34-38 Southampton Street, Reading

NMA application - supporting document

April 2022
RevA - drawing list updated
RevB - elevation detail drawings added

Proposed Elevations Detail

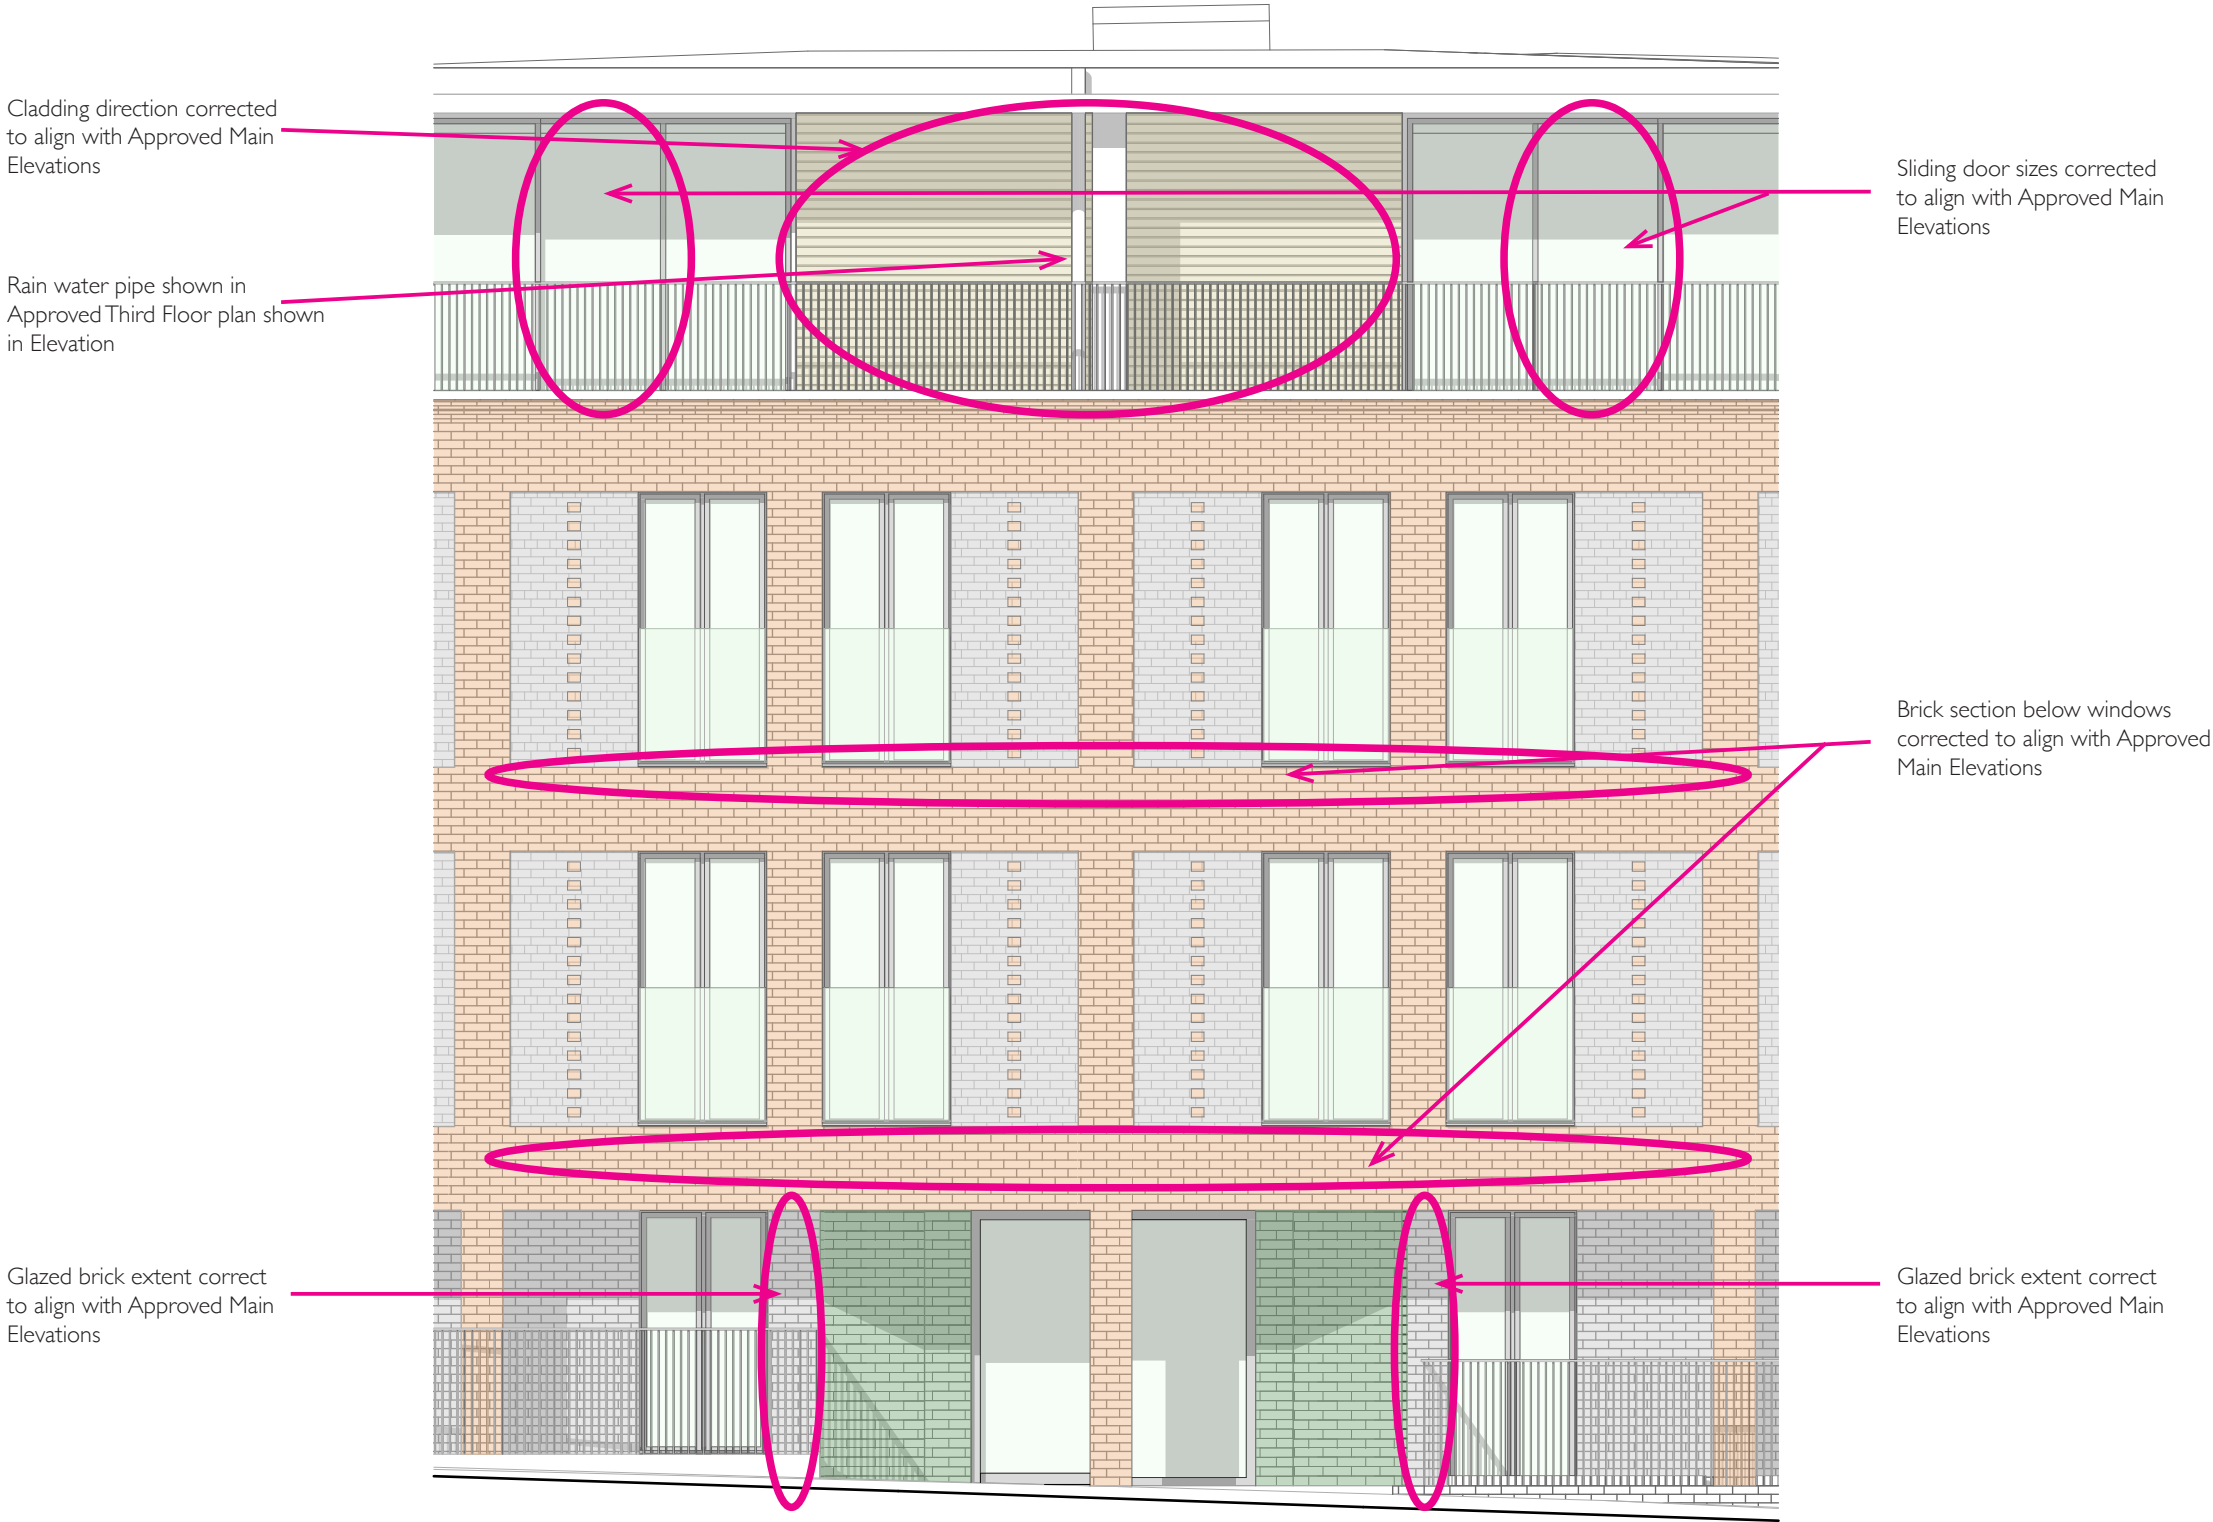
On the front elevation detail, some minor corrections have been made to bring this detail inline with the approved Main Elevations and Approved Plans. All other external elements on ground first second and third floor (except roof massing reduction noted above) remain as consented.
